Response to EPA Information Request for C3 Petrochemicals LLC
Propane Dehydrogenation Plant - Chocolate Bayou Plant
Application for Greenhouse Gas Prevention of Significant Deterioration Permit

Process Flow Diagram, Sheet 1

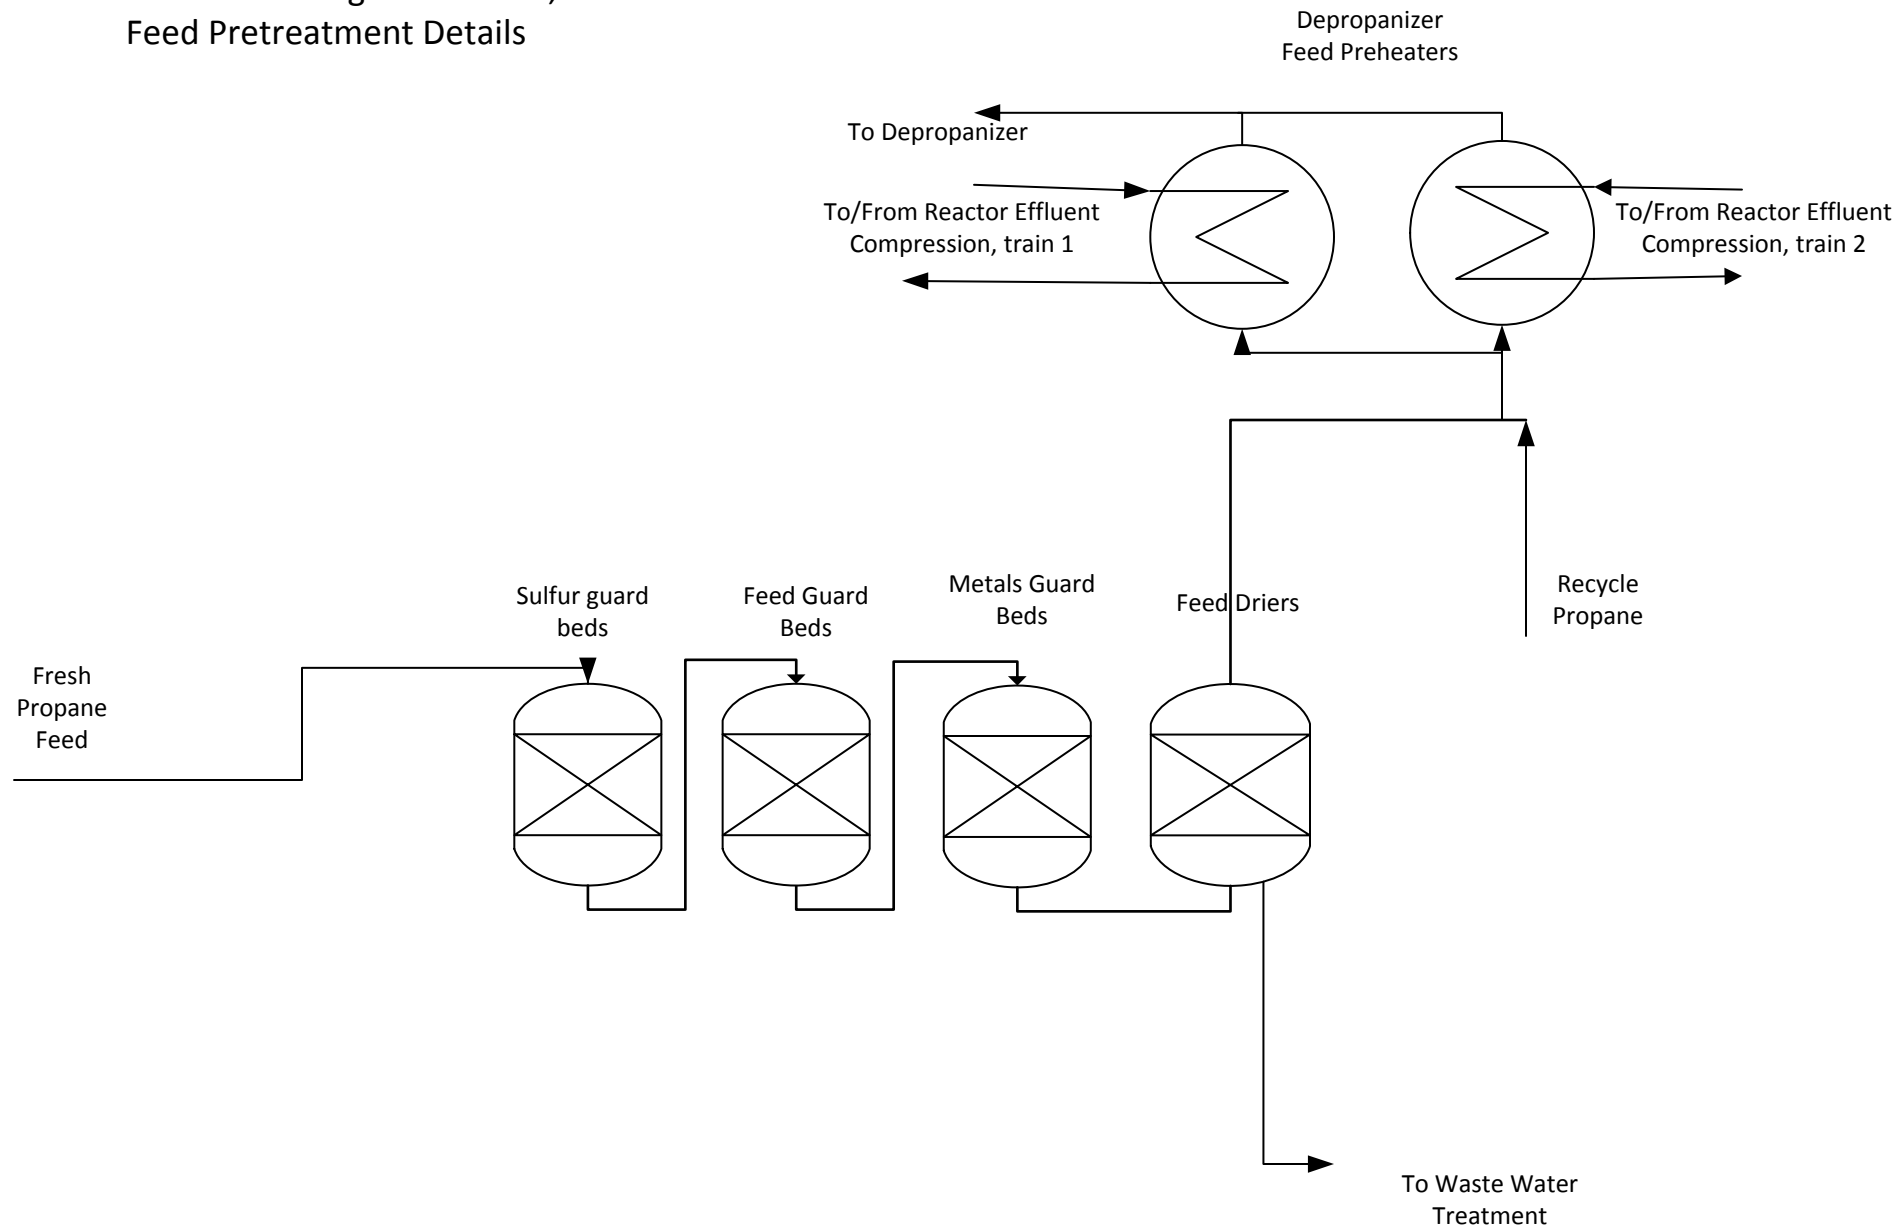
1. The process description should closely follow the process flow diagram that is provided and identify all emission points that emit GHG emissions or have the potential to emit. Also, include non-GHG sources, but please identify as such, if it is an integral part of process and feeds a GHG source. It is suggested that additional pages be created and provided to EPA to represent the process to avoid overcrowding and confusion. Please supplement the C3 Petrochemicals (C3P) propane dehydrogenation (PDH) plant process flow diagram with the following information:

- E. On page 21 of the application in the "Heavies Removal" section, it is stated that the propane feed is routed to a series of two depropanizer columns and that overhead product (propane) is obtained from both columns. In the first depropanizer column, heavier components (primarily butane and heavier) are drawn off as bottom fraction (C4+ fraction). The second depropanizer column is subsequently utilized to separate butanes from heavier components. The butanes will be stripped in this second depropanizer column and sold as product. The bottoms from the second depropanizer column (C5+) are stored as liquids in a storage tank that is vented to the flare. These liquids are subsequently loaded into tank trucks and transported off-site. The process description given indicates that the overhead product from both depropanizer columns is propane. However, the process description indicates that butane will be stripped and obtained as product from the second depropanizer as well.

- I. On page 22 of the application in the "Reactor Effluent Compression and Treating" section, it is stated that the hot reactor effluent from the fourth reactor is cooled with the reactor feed exchanger and compressed. Is this the same heat exchange that is mentioned previously on page 21 in the "Heavies Removal" section of the application or is this a different heat exchanger? The application states that the reactor effluent is sent through a drier. The drier is not shown on the process flow diagram. Will waste water be generated from this system? If so, please update the process flow diagram. The dried, compressed reactor effluent is then sent to a cryogenic separation system. A heavy aromatic solvent is occasionally injected into this section. Please update the process flow diagram to show this solvent injection into this system. The heavy aromatic tank and spent solvent tank both vent to the unit flare. How is the solvent removed from the process? Is there additional equipment used? If so, please update the process flow diagram to show the additional equipment.

- M. On page 24 of the application, it is stated that the fuel gas system includes natural gas and process fuel gases. The process flow diagram indicates the streams that comprise the fuel system, but does not appear to indicate the equipment that will utilize the fuel gas system. Please update the process flow diagram to show where the fuel from the fuel gas system will be used.

C3P RESPONSE: A revised overall process flow diagram for the PDH process is included as Sheet 1 of the attachments. More detailed process flow diagrams for each reactor train are also attached. Sheet 3 provides the requested detail for reactors and heaters in Train 1. Sheet 4 provides this detail for the reactors and heaters in Train 2.

C3P RESPONSE: The design of the PDH plant has been modified since the permit application was submitted. This design now includes only one depropanizer column. The block flow diagram (Sheet 1) and the process description have been updated to reflect the change. A copy of each is attached to this response. C4 product will be recovered as a sidedraw from the single depropanizer column. The C5+ fraction is withdrawn from the column bottoms.

C3P RESPONSE: The block flow diagram (Sheet 1) and the process description have been updated to reflect the change to a single depropanizer column. A copy of each is attached.

C3P RESPONSE: The heat exchange described in "Reactor Effluent Compression and Treating" section occurs in the hot combined feed exchangers. This heat exchange was described previously in the "PDH reaction" section. It is not the same heat exchange mentioned under "heavies removal" which describes the depropanizer feed preheaters. The process description has been revised to clarify this point. No waste water is generated from the reactor effluent drier. The drier removes extremely small amounts of water generated in the reactor. The rejected water is not condensed and is rejected into the process gas stream during regeneration of the driers. Ultimately the rejected water is part of the tail gas stream from the PSA and exits via the fuel gas system. The solvent drum used for solvent injection and removal has been added to the process flow diagram Sheet 1.

C3P RESPONSE: Fuel from the fuel gas system will be utilized by the boilers and by the process heaters in the reaction section of the PDH plant. The overall process flow diagram on Sheet 1 has been updated to show the users of the fuel gas system.

C3 Petrochemicals LLC – PDH Plant
Process Flow Diagram Sheet 2,
Feed Pretreatment Details

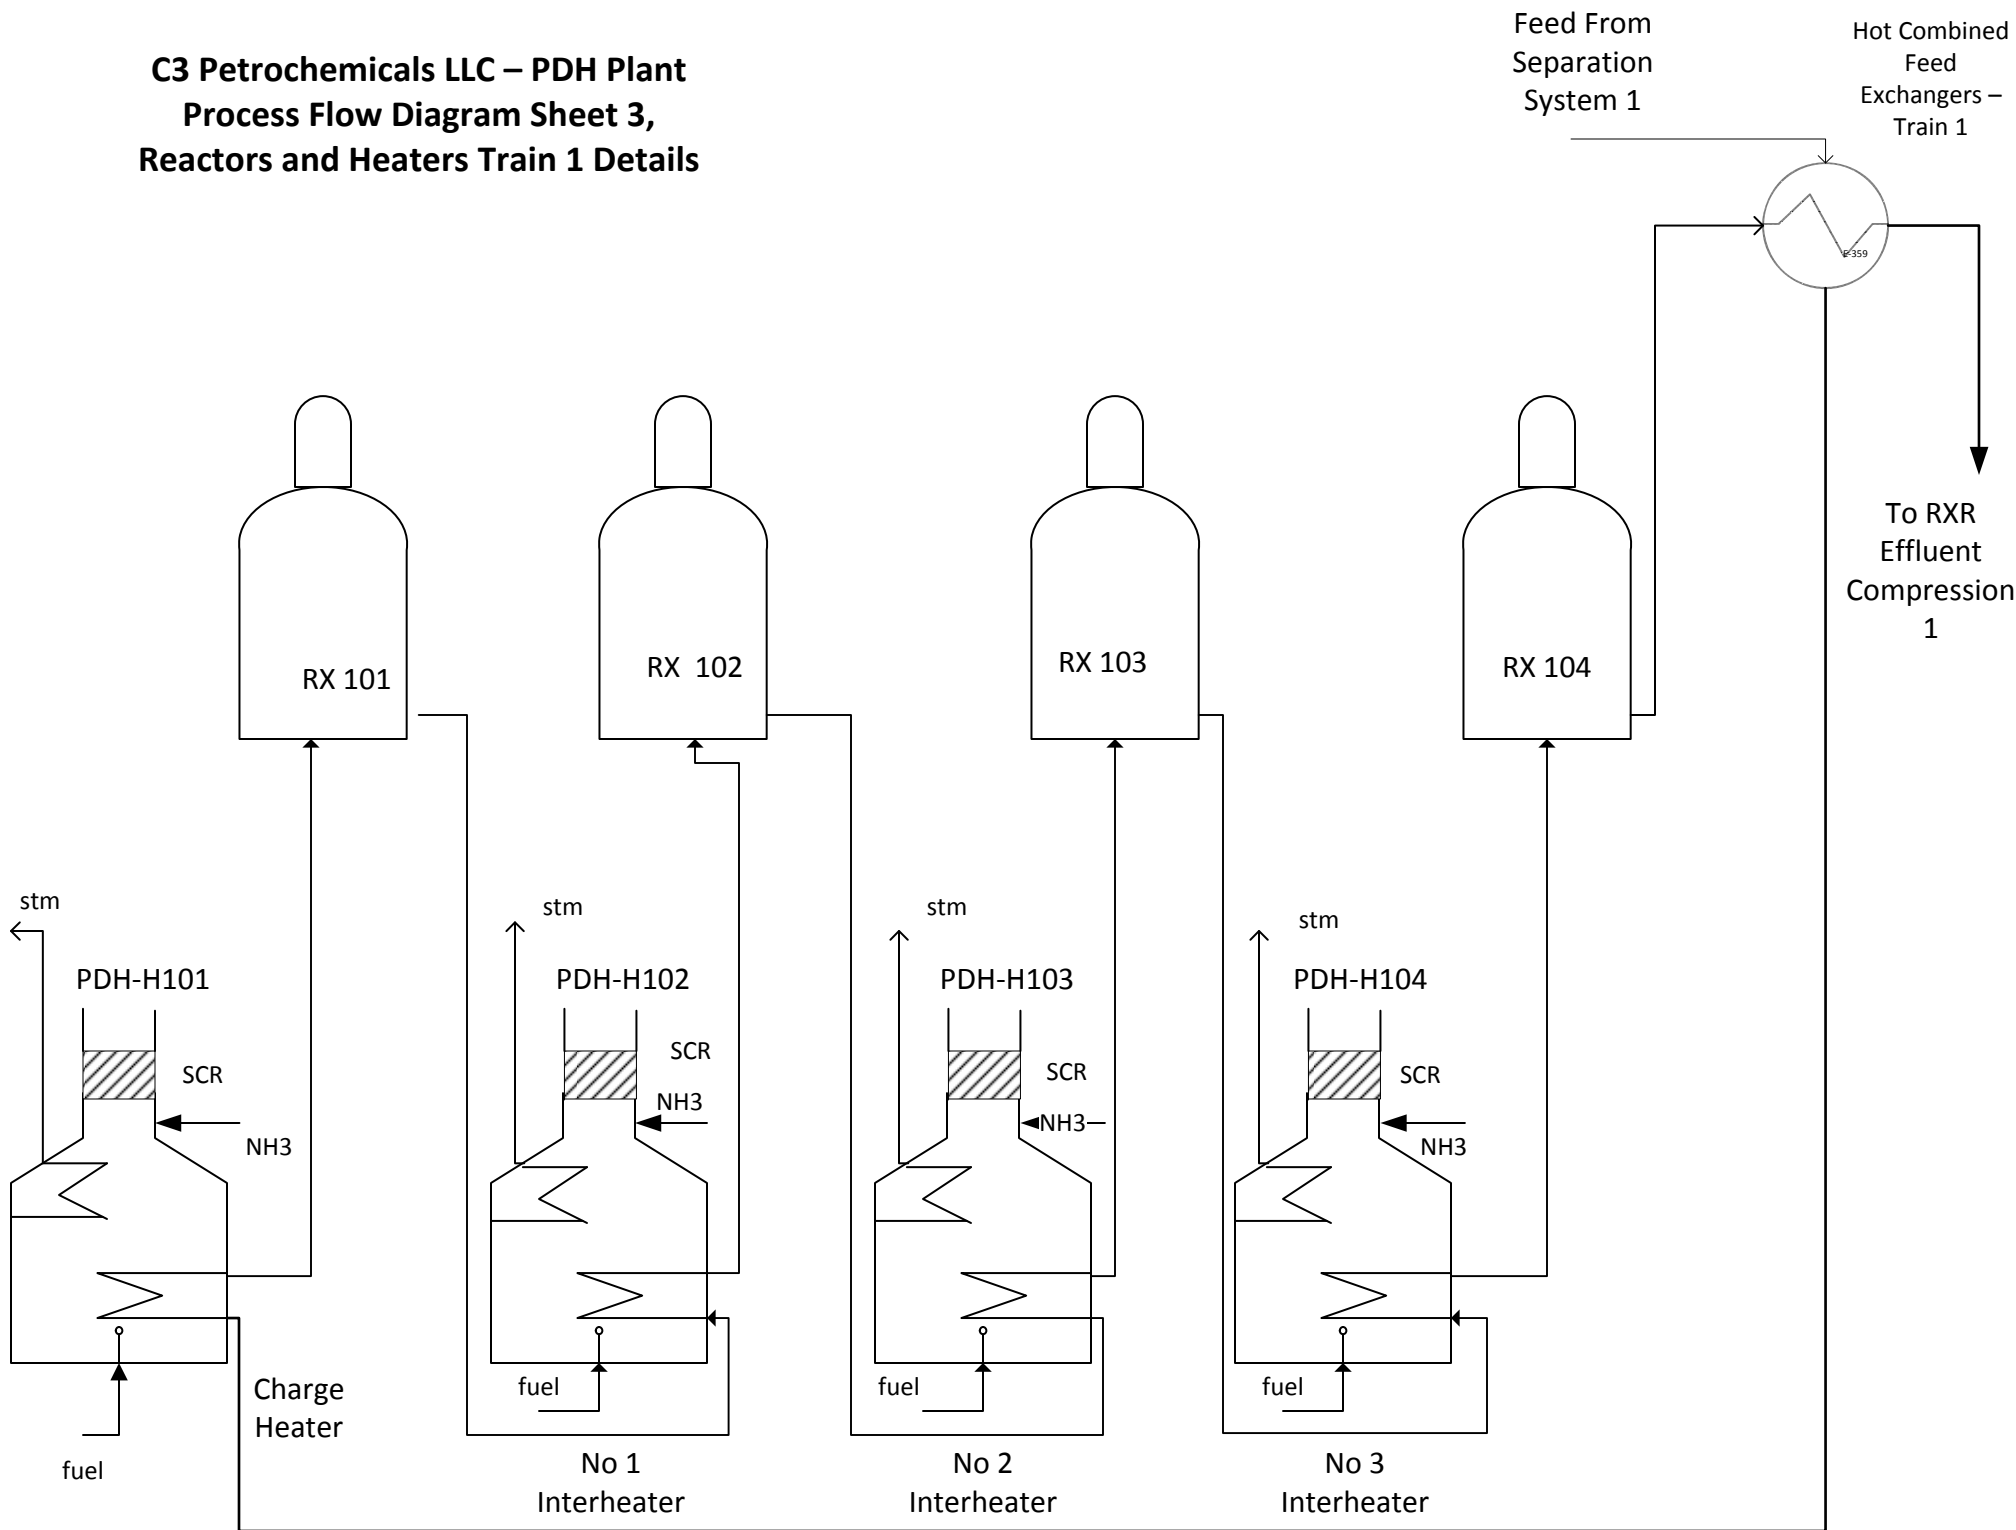
- B. The heat recovery that is mentioned throughout the process description should be shown on the process flow diagram. This includes, but is not limited to, after feed pre-treatment, propane feed is exchanged with hot reactor effluent to pre-heat the feed, the overhead product (propane) for the first and second depropanizer columns are cooled and routed to the separation section (coldbox) of the process, the cooled propane feed from the separation section is routed to the PDH reaction section where it is heated via the feed exchanger and then routed to the reactors.

- C. On page 20 of the application in the "Feed Pretreatment" section, it is stated that before the propane enters the PDH reaction section of the unit, impurities and moisture are removed. Metals and sulfur compounds are removed via the use of guard beds. Moisture is removed from the propane feed via the use of feed driers and a small volume of waste water will be generated from the regeneration of the feed driers. Please update the process flow diagram to show this equipment and the waste water directed away from the drier.

C3P RESPONSE: Process flow diagrams are included to provide additional detail regarding the heat recovery described in the PDH process description. This heat recovery is shown in the following: Sheet 2 (after feed pre-treatment), Sheet 6 (overhead product from depropanizer cooled and routed to the separation section), Sheets 3 and 4 (feed from the separation section routed to the PDH reaction section).

C3P RESPONSE: The depropanizer feed preheaters are designed to recover 72% of the available heat from the compressed reactor effluent into the depropanizer feed stream (Sheet 2). The hot combined feed exchangers are designed to recover 85% of the available heat from the reactor 4 effluent stream (Sheets 3 and 4). It is difficult to quantify the overall efficiency of the cold box (Sheet 6), but the feed chiller and cold combined feed exchanger in the cold box use 100% of the available heat from the condensation of the

C3P RESPONSE: Sheet 2 of the attached process flow diagrams provides the details of feed pretreatment, including the feed driers and waste water from these driers.

C3 Petrochemicals LLC – PDH Plant
Process Flow Diagram Sheet 3,
Reactors and Heaters Train 1 Details

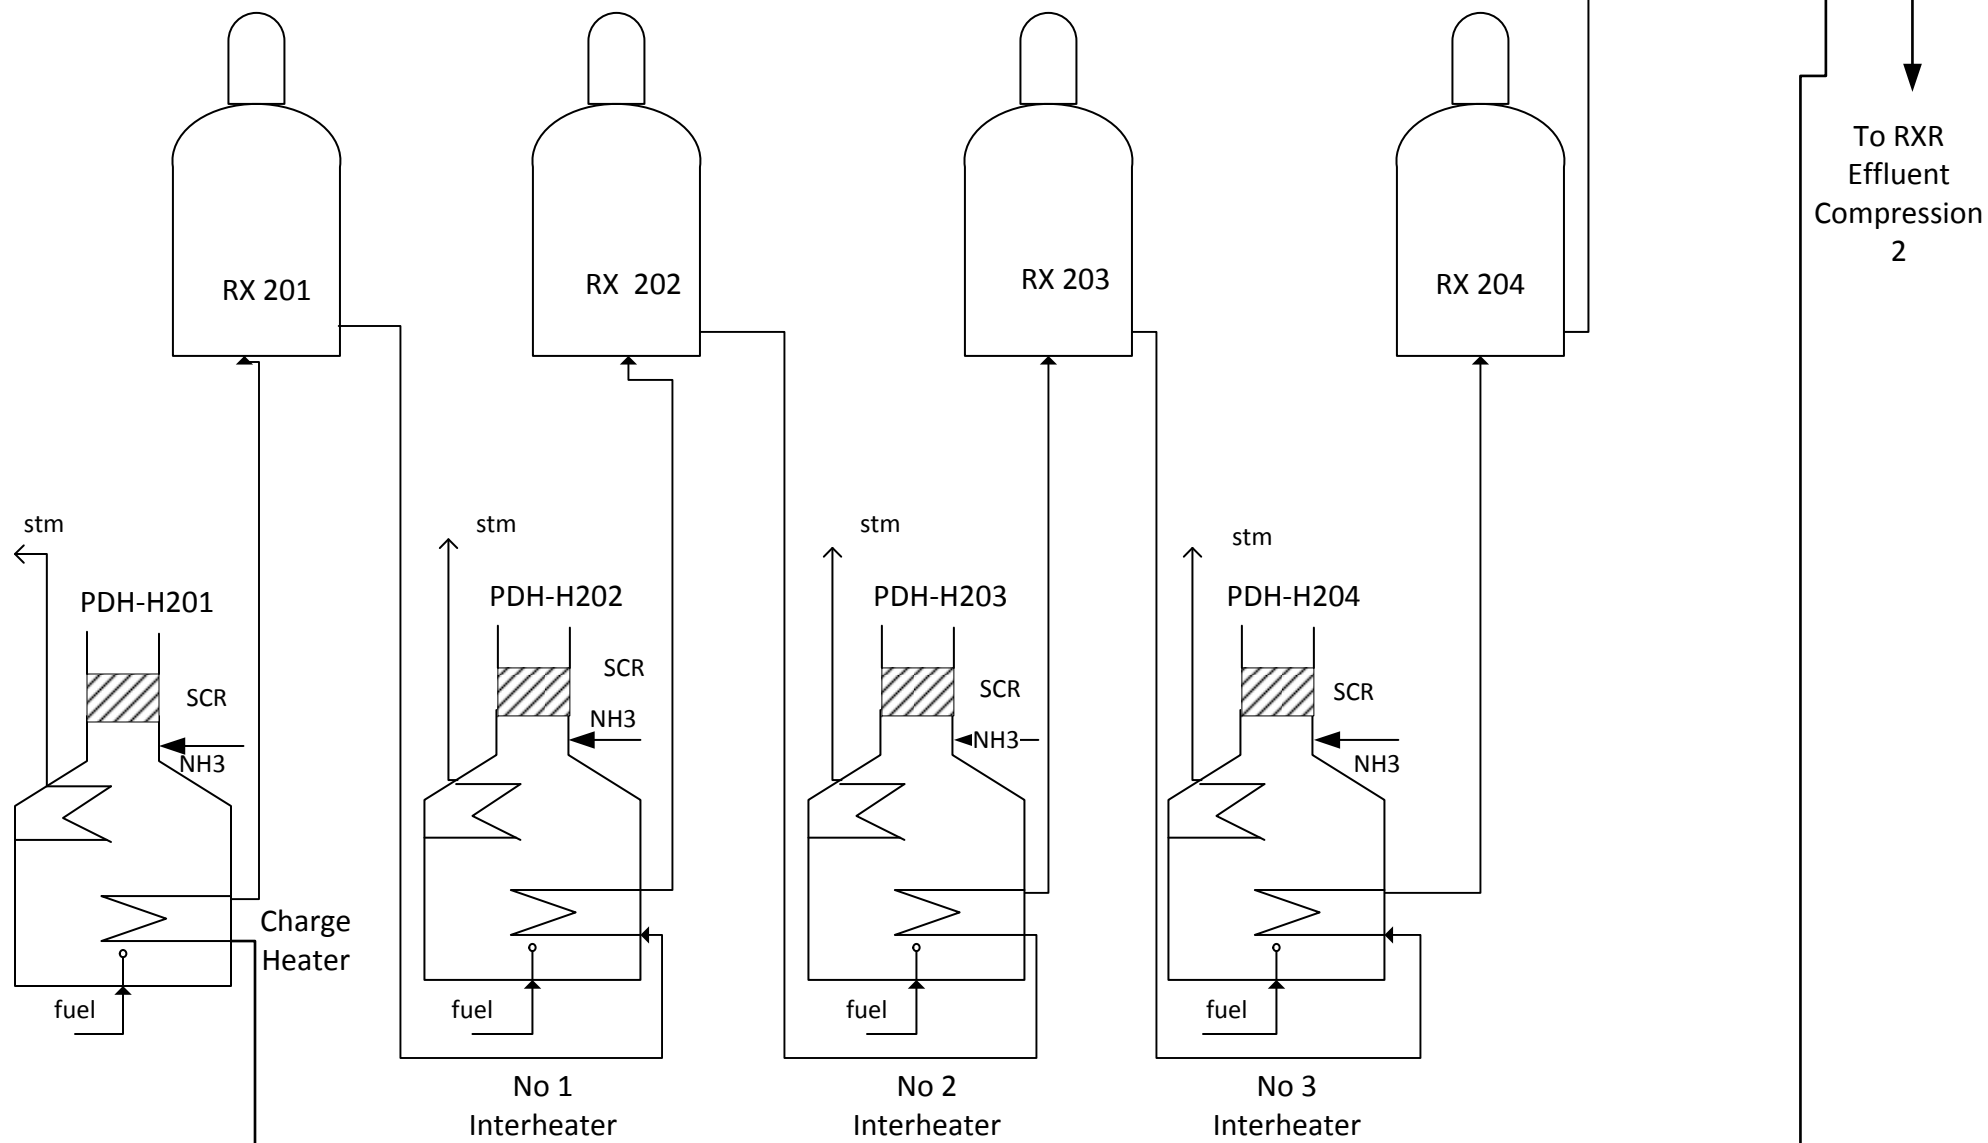
- A. A representation of the two trains with four reactors in series along with the emission point identification numbers. Please include the charge heaters that are prior to the first reactors in series and the inter-heaters that are prior to the second, third and fourth reactors in series. On page 21 of the application, it is stated that ultra-low NO_x burners and selective catalytic reduction (SCR) will be used on the charge heaters and the three inter-heaters on each reactor train. Please show the SCR add-on pollution control device to be used on the heater.
